MANDO PARKING LOT EXPANSION JSP24-11

Public Hearing at the request of Tower Construction LLC, for the Mando Parking Lot Expansion JSP24-11 for Preliminary Site Plan, Woodland Permit and Stormwater Management Plan approval. The subject parcel is zoned I-1, Light Industrial and is located east of Hudson Drive and south of Hexagon Way in the Beck North Corporate Park. The applicant proposes to construct a new 37-space employee parking lot and is seeking approval to remove 53 regulated woodland trees.

PLANNING REVIEW

Review Date: April 4, 2024
Review Type: Revised Final Site Plan
Project Name: JSP24-11: Mando Parking Lot Expansion
Location: Beck North Corporate Park
Plan Date: March 19, 2024
Prepared by: Heather Zeigler, Planner
E-mail: heigler@cityofnovi.org; **Phone:** (248) 347-0579

PRELIMINARY GRADING PLAN

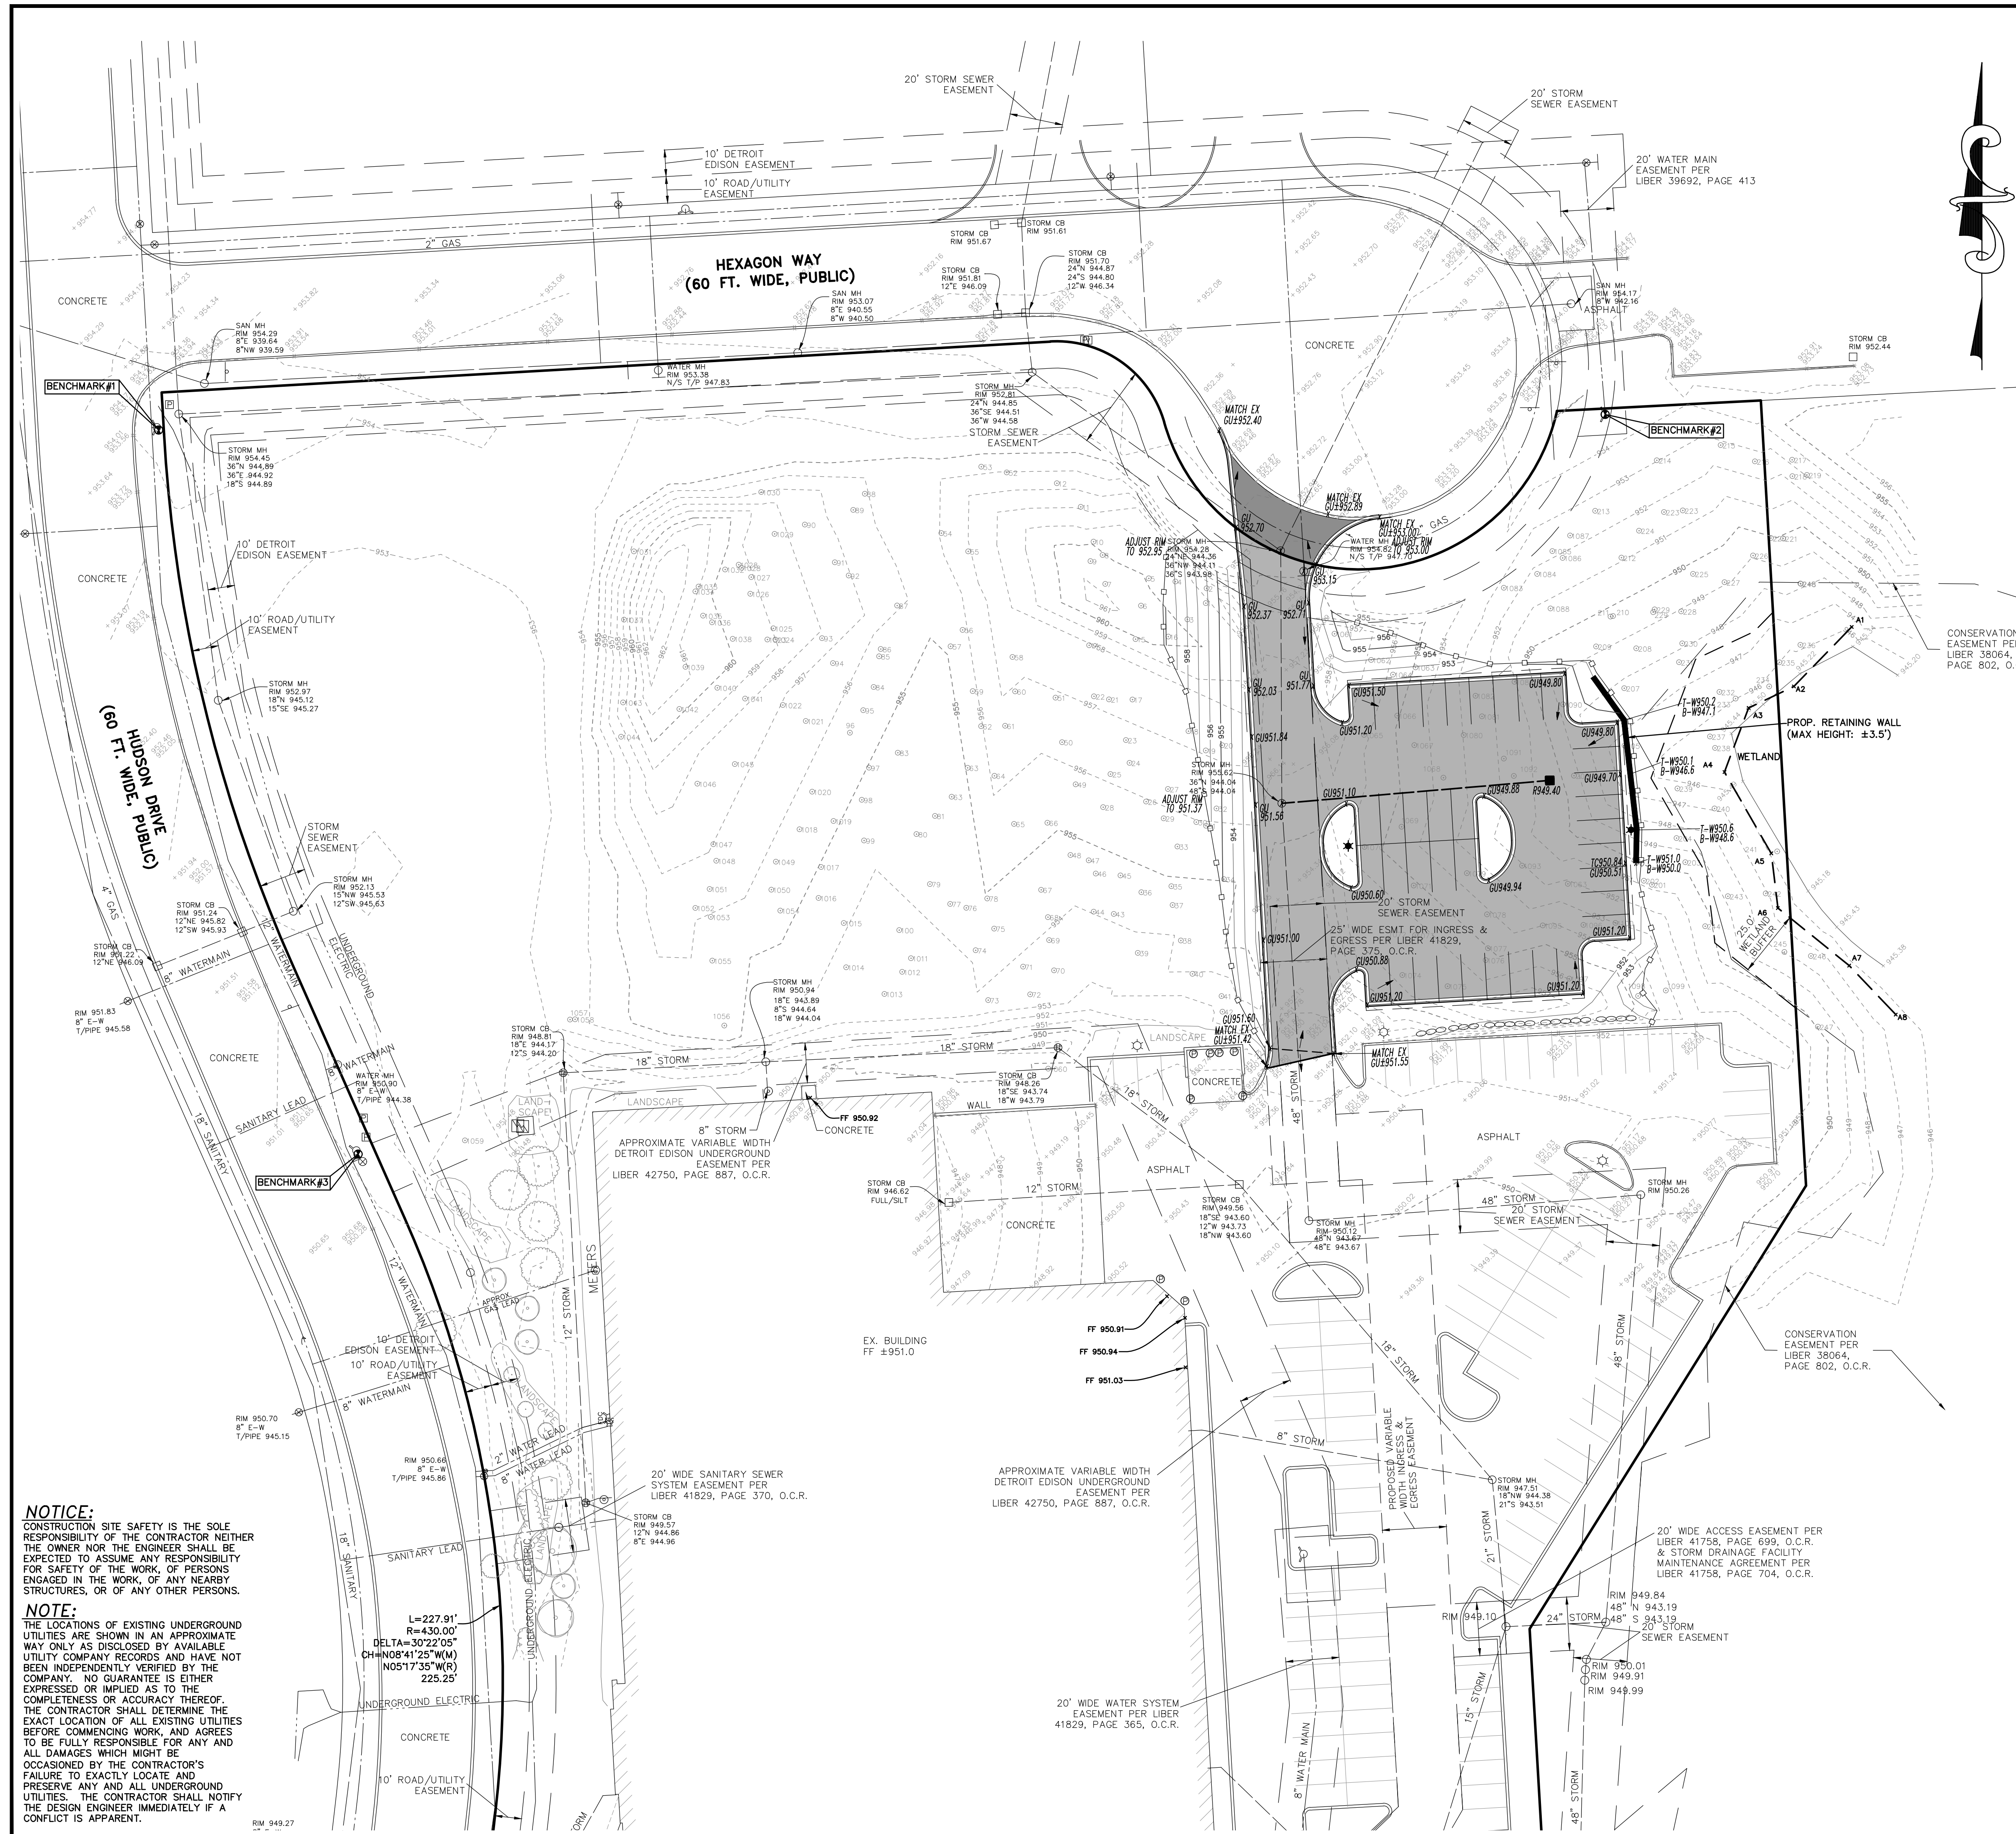
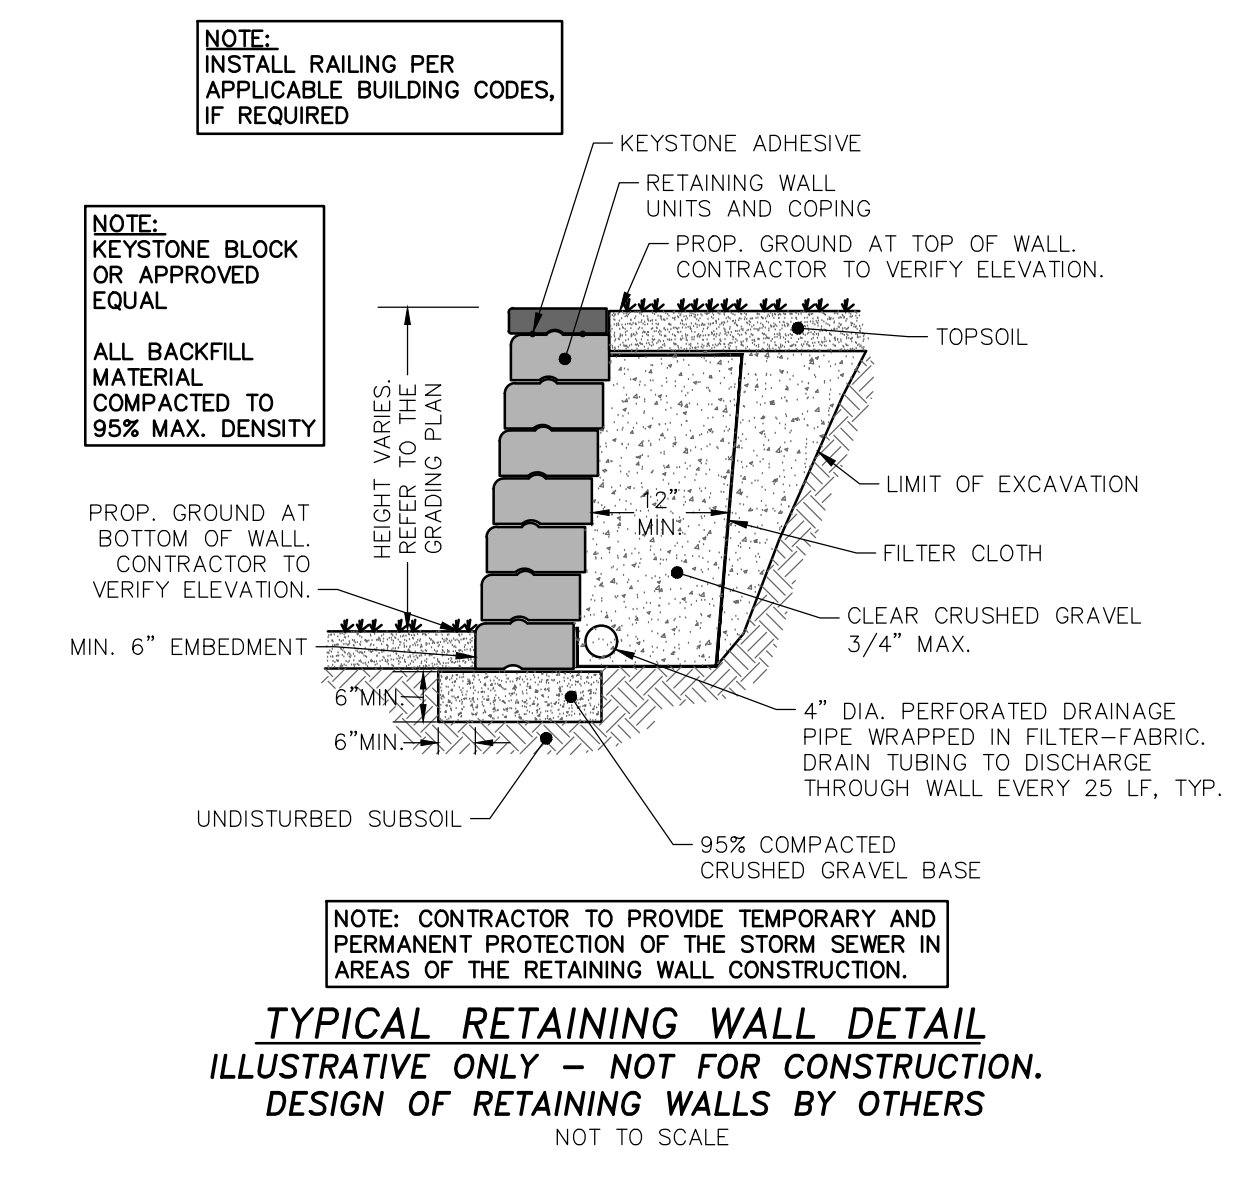
24. Provide top of curb/walk and pavement/gutter grades to indicate height of curb adjacent to parking stalls or drive areas.
25. Sheet 3 shall be signed and sealed by the design engineer responsible for the proposed retaining wall design and all associated calculations.

Woodland Plan

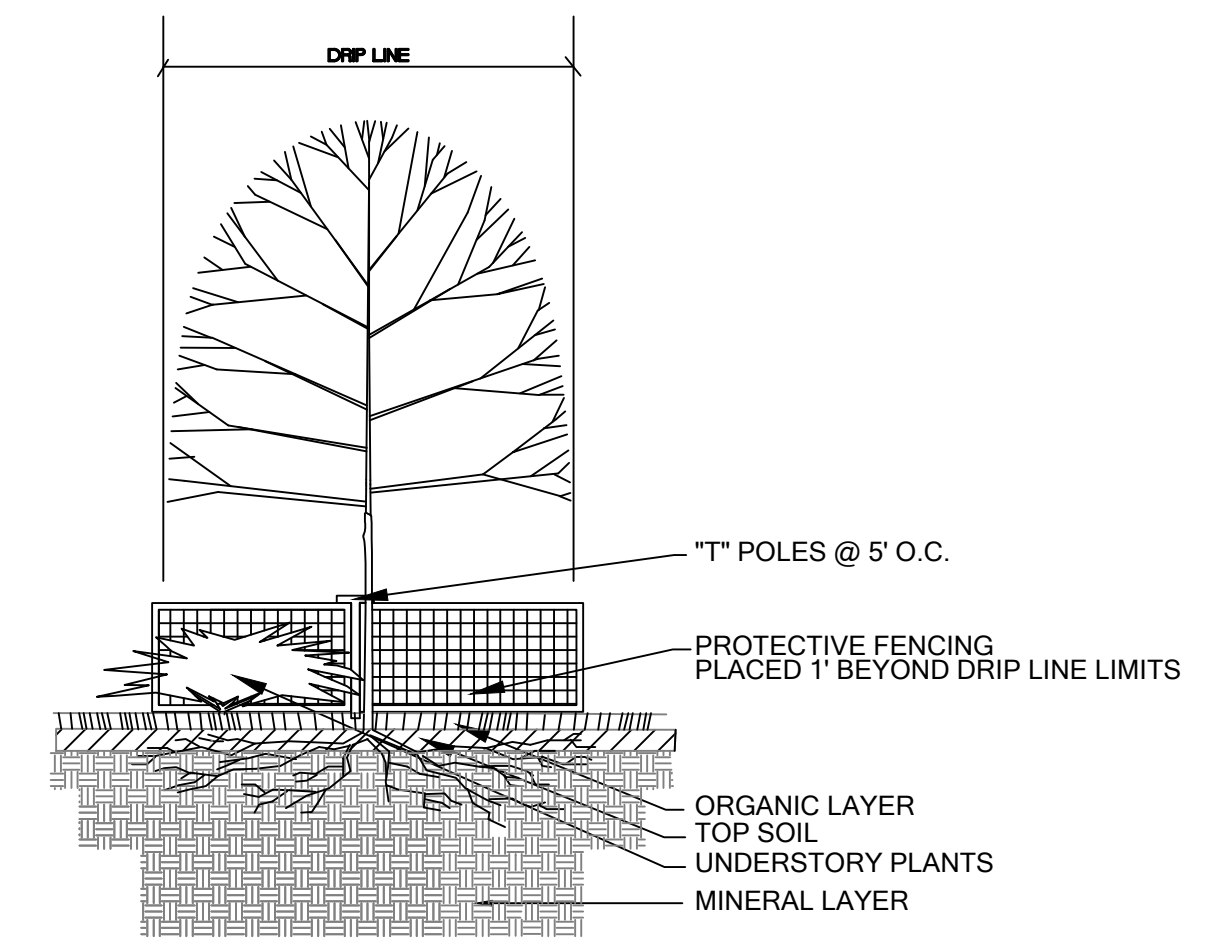
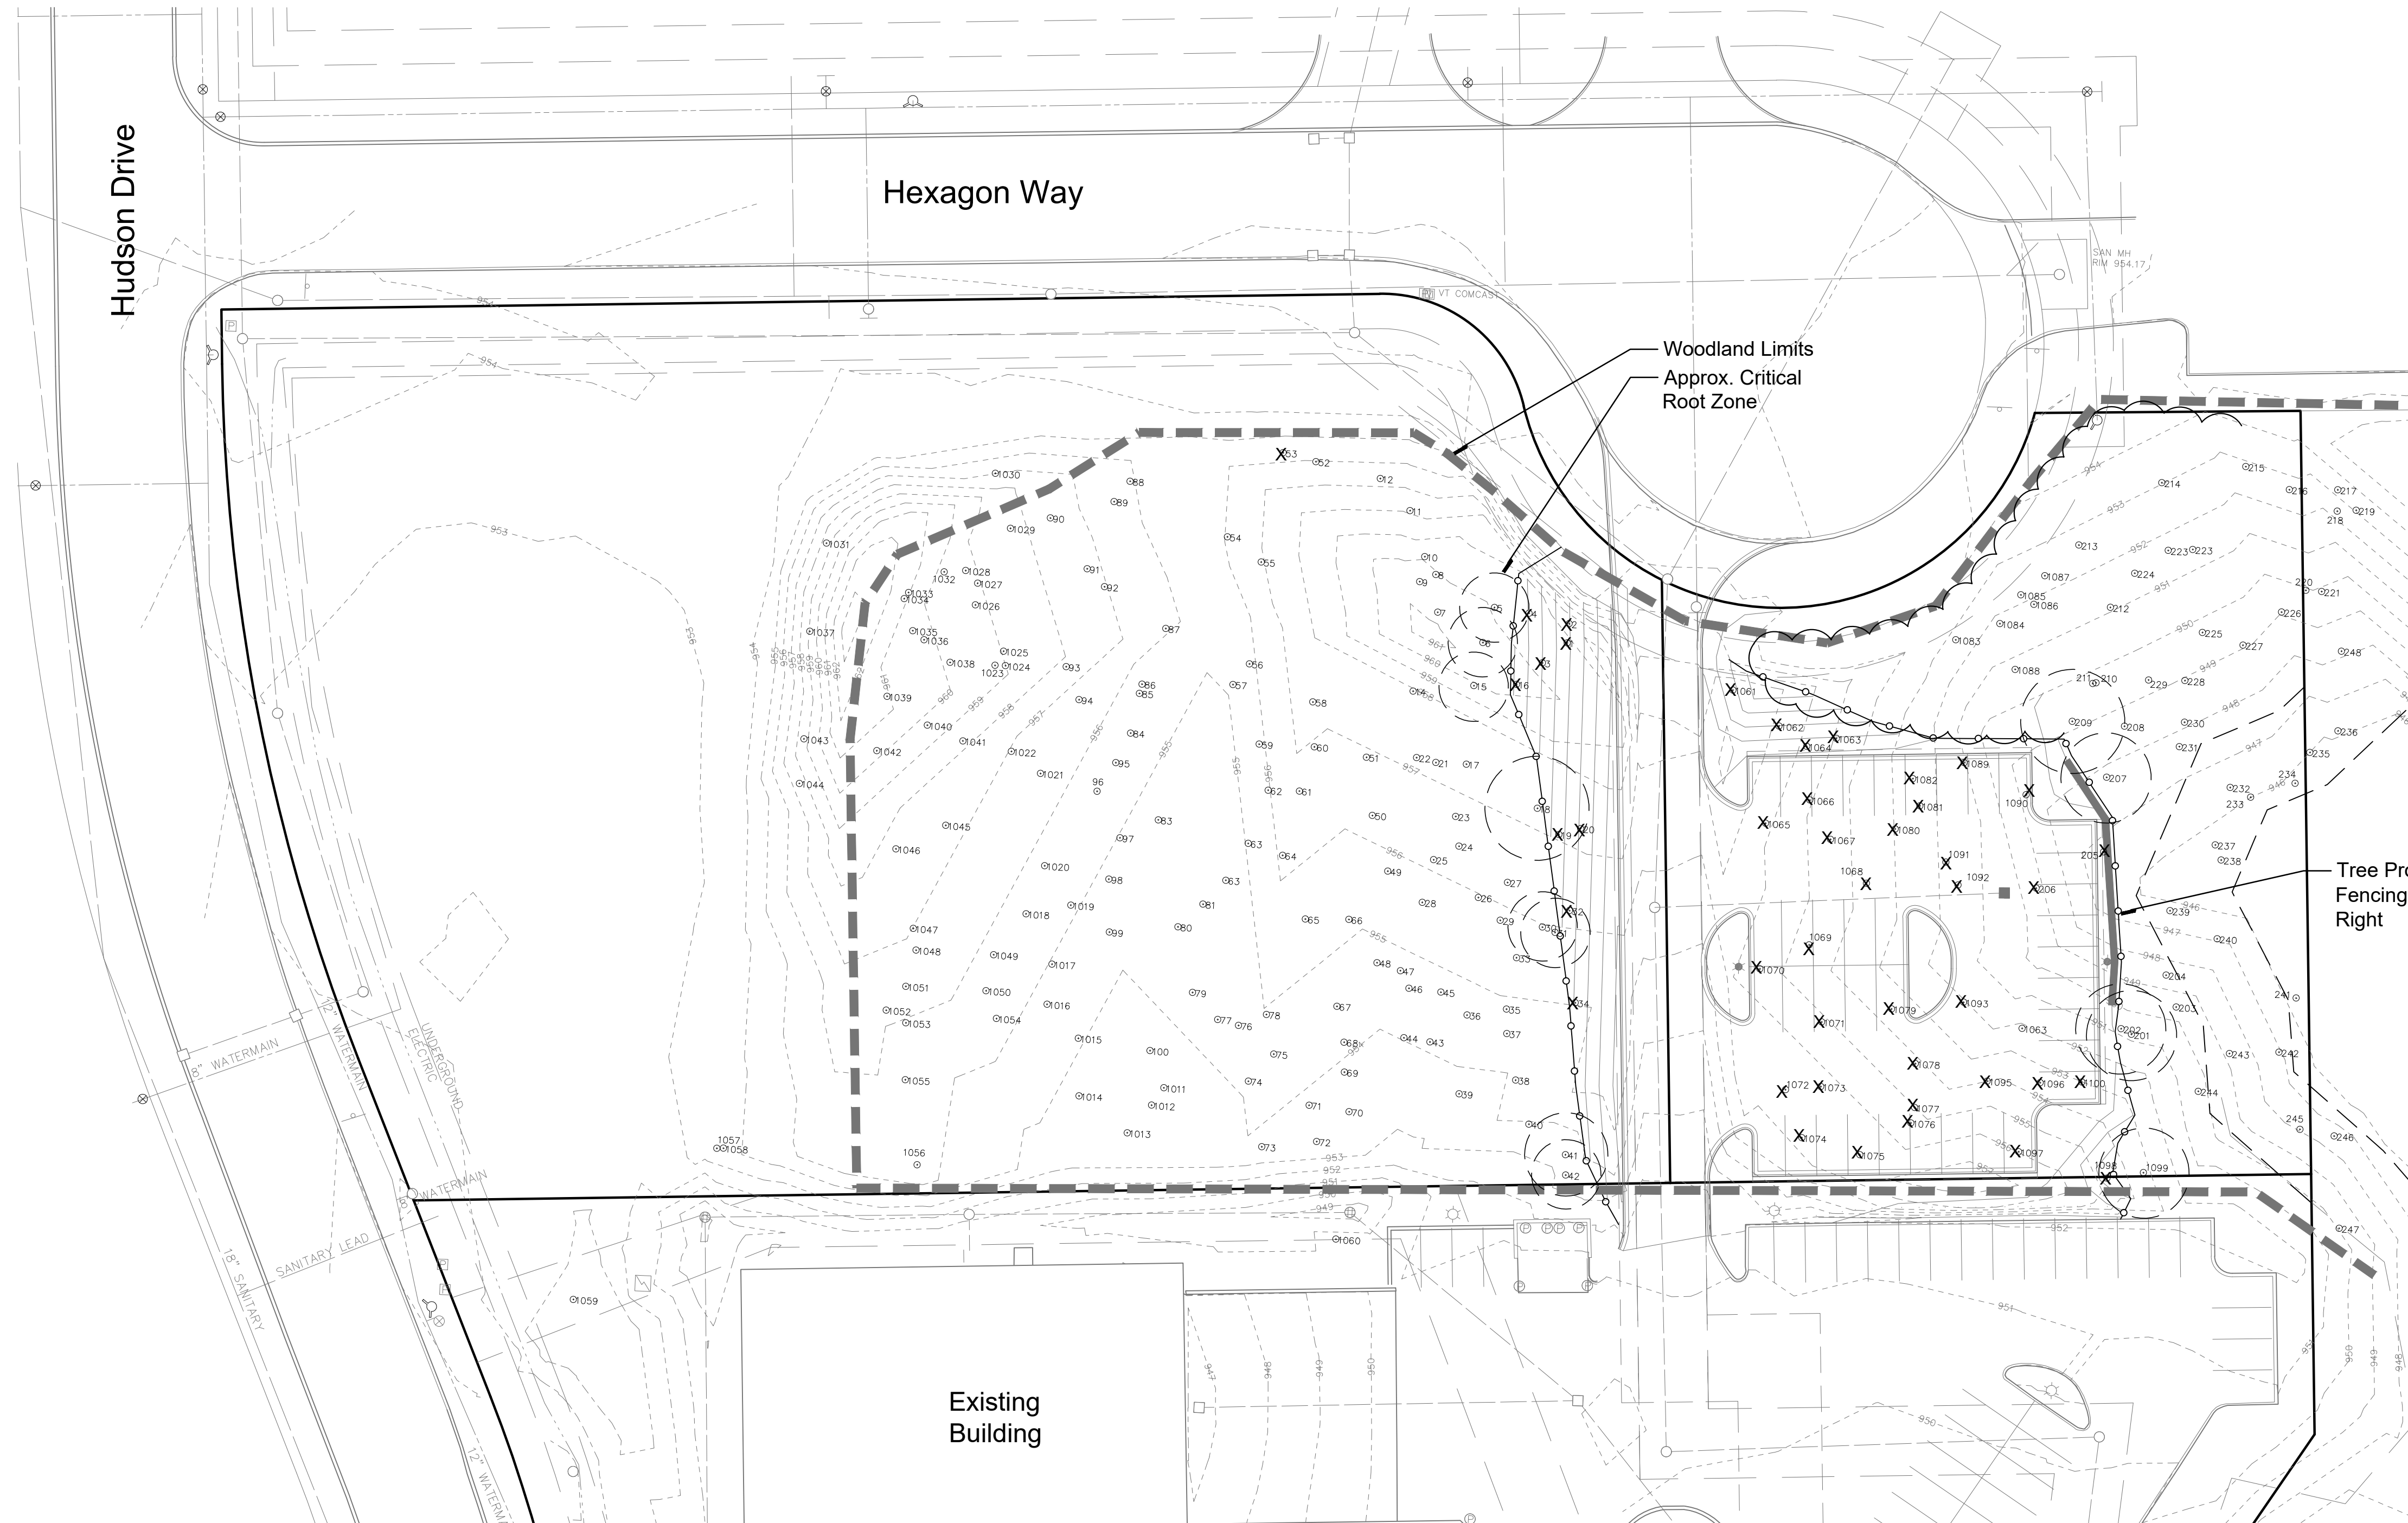
- a. The applicant has accurately depicted root zones on Sheet L-3 and has indicated the critical root zone impacts in the tree list on Sheet L-4.
8. The applicant has stated that no trees will be planted toward woodland replacements and all 72 tree replacements will be paid for into the City of Novi Tree Fund in an amount of **\$28,800** (72 x \$400/tree). It is encouraged that prior to paying into the City of Novi Tree Fund, the applicant try to mitigate the proposed removals on-site to the maximum extent practicable via planting woodland replacements.
